MSAC Traffic Subcommittee

Historical Perspective of Walnut Street (Pre-MarketStreet) Traffic

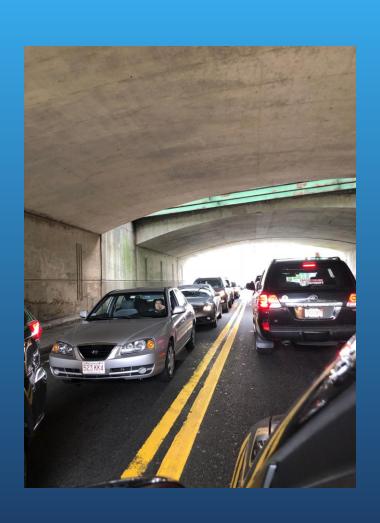
Exit Ramp from 128 North & Congestion at MarketStreet - Saturday, March 31, 2018 @ 1:40PM

Heading South on Walnut Street to MarketStreet - Saturday, March 31, 2018 @ 2:07 PM

Congestion on Walnut Street - Thursday, May 4, 2018 @ 12:05 PM

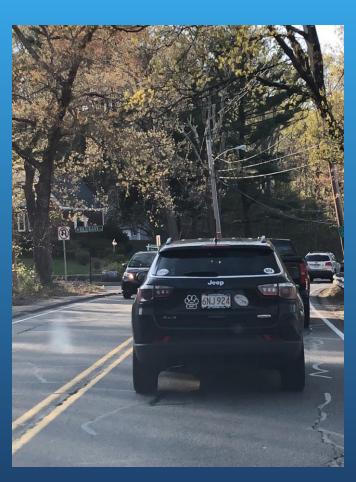
Heading North on Walnut Street Monday, May 7, 2018 @ 5:56 PM Traffic backed up to Blue Jay Road

Heading North on Walnut Street Monday, May 28, 2018 @ 2:44 PM Non-MarketStreet drivers are forced to stop and wait until long line of cars are able to turn left into MarketStreet

Heading South On Walnut Street Tuesday, May 29, 2018 @ 11:15 AM Traffic Backed Up to Alexandra Road

"On a recent Saturday afternoon, 3 members of security were necessary to direct traffic in the MarketStreet rotary. Traffic was backed up on Walnut Street in both directions, down the ramp from 128 South and in almost all directions within the rotary. Resident started at the traffic light on Walnut Street to the circle near Panera Bread and then back as the traffic still hadn't cleared on my return trip."

Walnut Street - Residents' Concerns

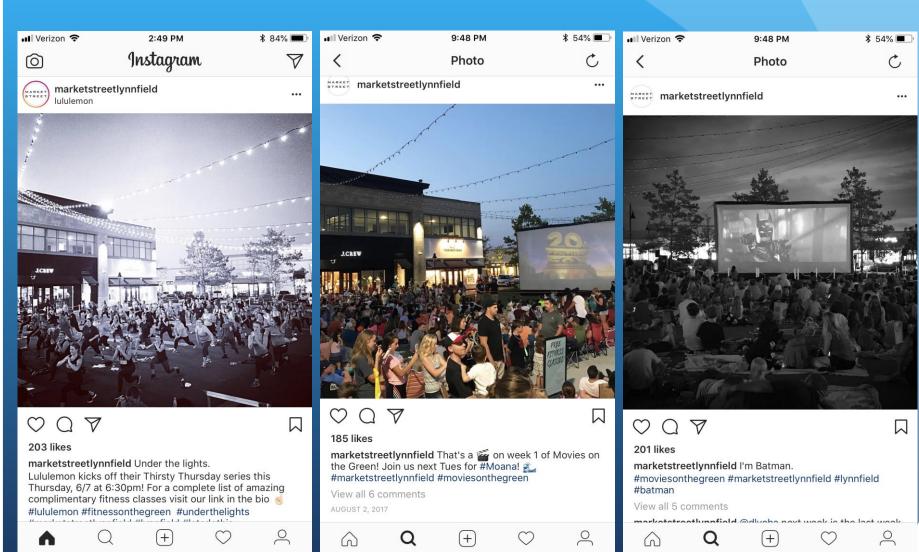
- Heading south on Walnut Street, you may have to wait for a few lights before you can make a right-hand turn into MarketStreet. Currently, there is not enough room for a car to make a right-hand turn into MarketStreet while traffic is stopped going south on Walnut Street.

- Heading north on Walnut Street, you are sometimes backed almost into Saugus due to the timing of the lights and the buildup of traffic.
- Traffic backs up taking a right or left from Salem Street onto Walnut Street due to the timing of lights. Residents have commented about sitting through several lights until they are able to take a turn.

- As traffic backs up for drivers taking a left turn into MarketStreet, non-MarketStreet drivers have to wait for several lights before being able to continue up Walnut Street.

- At times, especially on the weekends, traffic is backed all the way up the ramp to Route 128, which makes residents angry as they sit in traffic just trying to get home.
